Agenda Item No. 4a.

Staff Report

Subject: 3 Southwood Avenue (DRP26-06)

BRAVERMAN GARAGE

1 A1.1 PROPOSED SITE PLAN
1/8" = 1'-0"

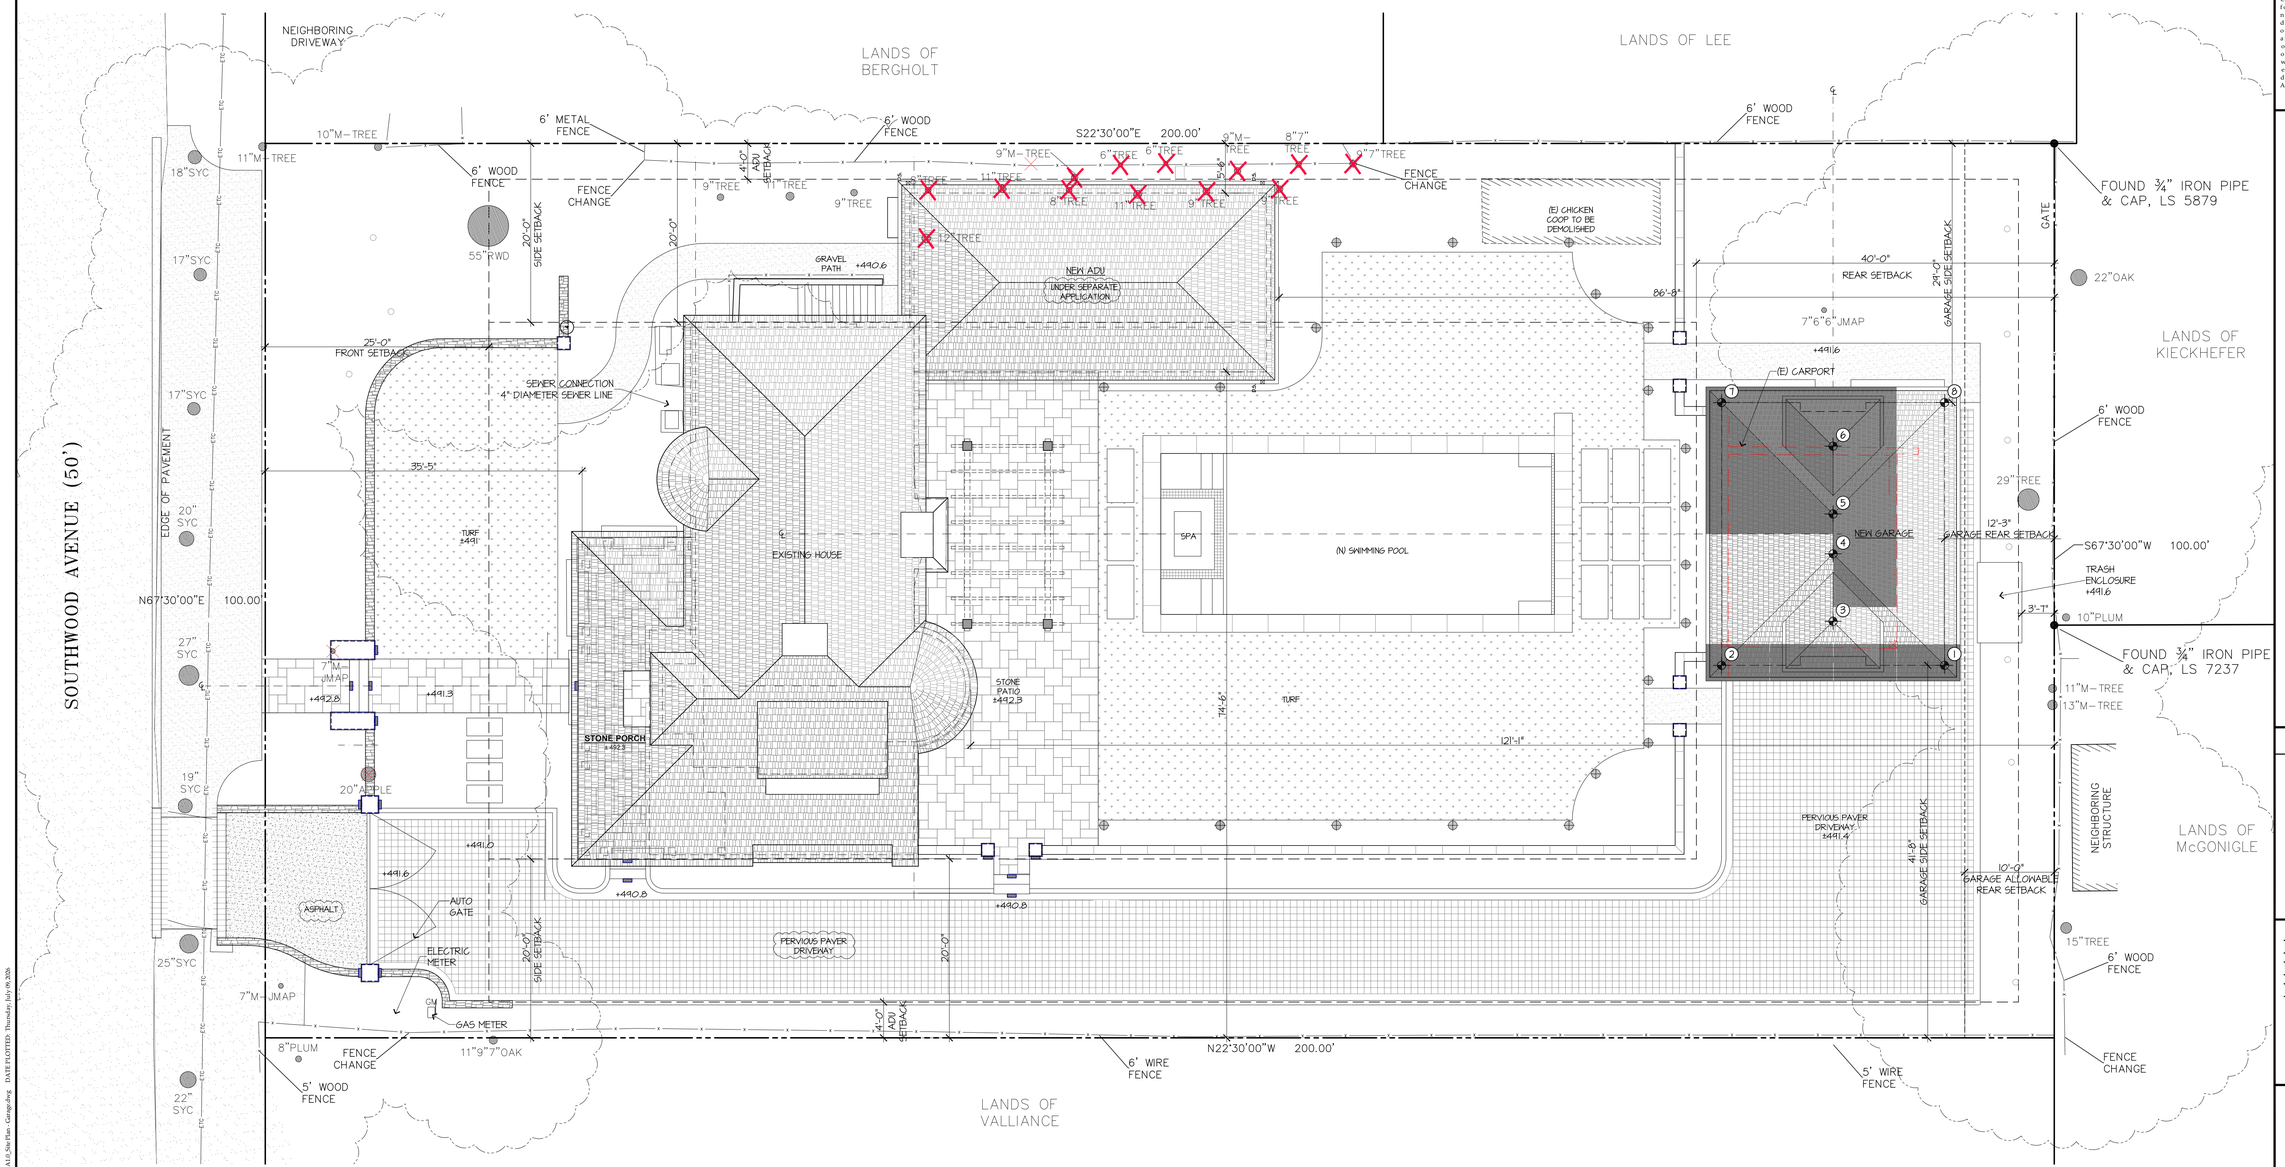
The applicants are requesting floor area and setback variances to replace an existing non-conforming 440-square-foot carport with a new 732-square-foot, two-story Garage/Bonus Room. This new structure as proposed would sit just 12 feet from their back property line, well short of the required 40-foot setback, and add considerable building mass and scale at a height detrimental to us and undoubtedly all neighboring parcels.

As precursor, please also note a meaningful error in the applicant's plans. The architect erroneously submits that a garage on this site is permitted a 10-foot setback. However, the Town of Ross has clarified that a standard 40-foot setback applies to this property. Any evaluation of this proposal needs to be based on the actual 40-foot setback requirement, rather than the minimized deviation presented in the plans.

Staff recommends that the applicant redesign the project to ensure the proposed garage remains within the existing nonconforming floor area, height and setbacks.

1 A3.2 SOUTH ELEVATION
1/4" = 1'-0"

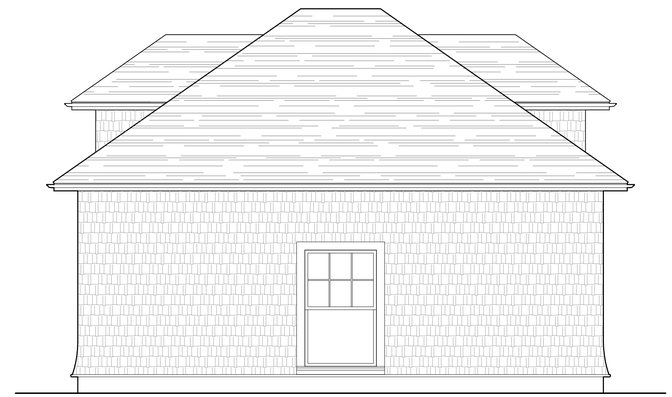
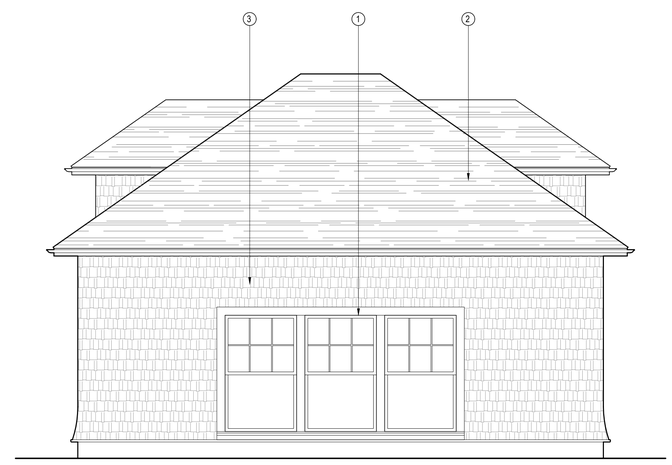
In the spirit of neighborly cooperation, we spoke with the applicants a few months ago and asked them to reconsider the two-story design proposal to protect our privacy and the neighborhood character. While they unfortunately decided to not make any modifications to their project at that time, we sincerely hope and believe they can achieve their upgrade goals with a single-story 440 square foot garage, and hope we can move forward in that vein.

GRADING AND DRAINAGE PLAN

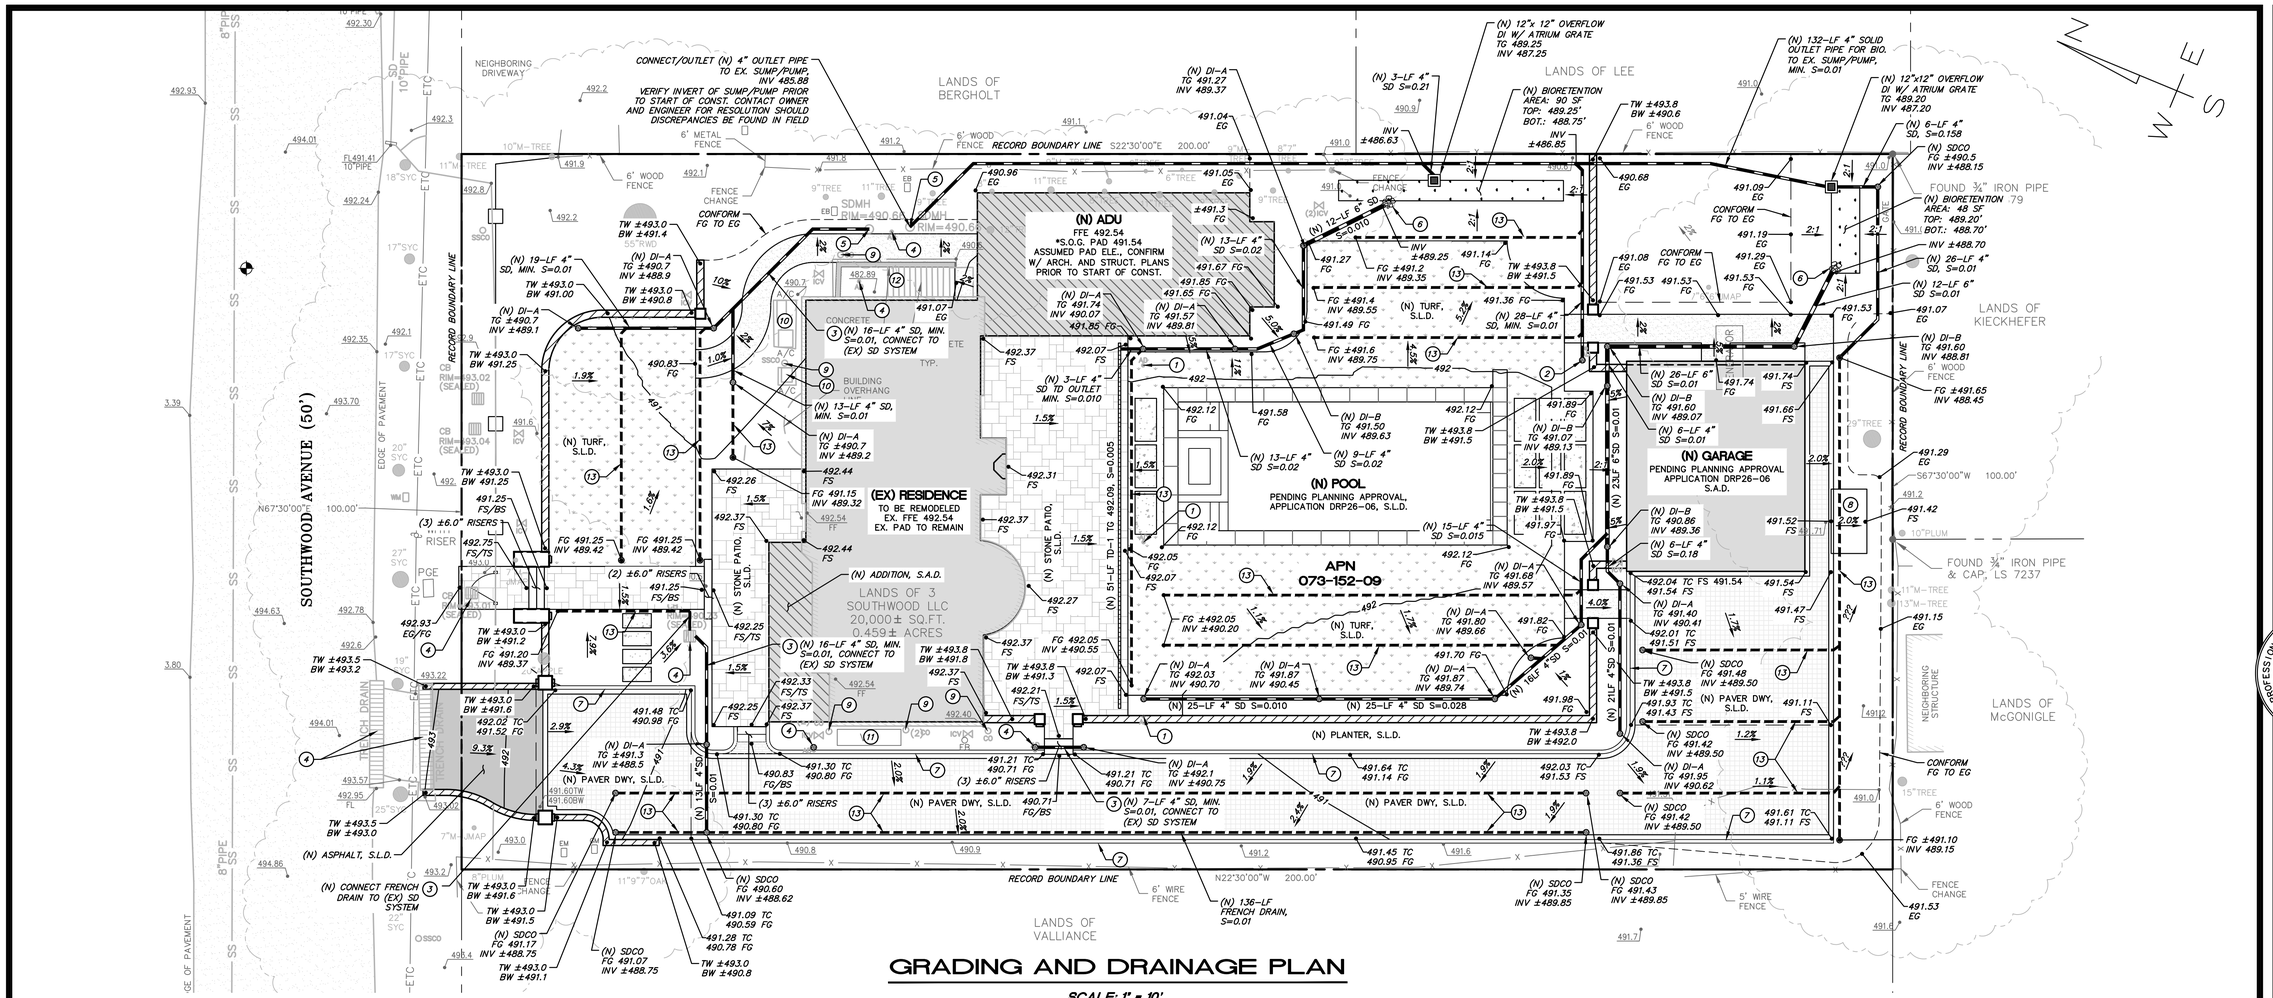
We respectfully ask the ADR to denying the variances for the two-story Garage/Bonus Room, and to rigorously review the drainage plans to ensure neighboring properties are protected from runoff from the overall project's impact.
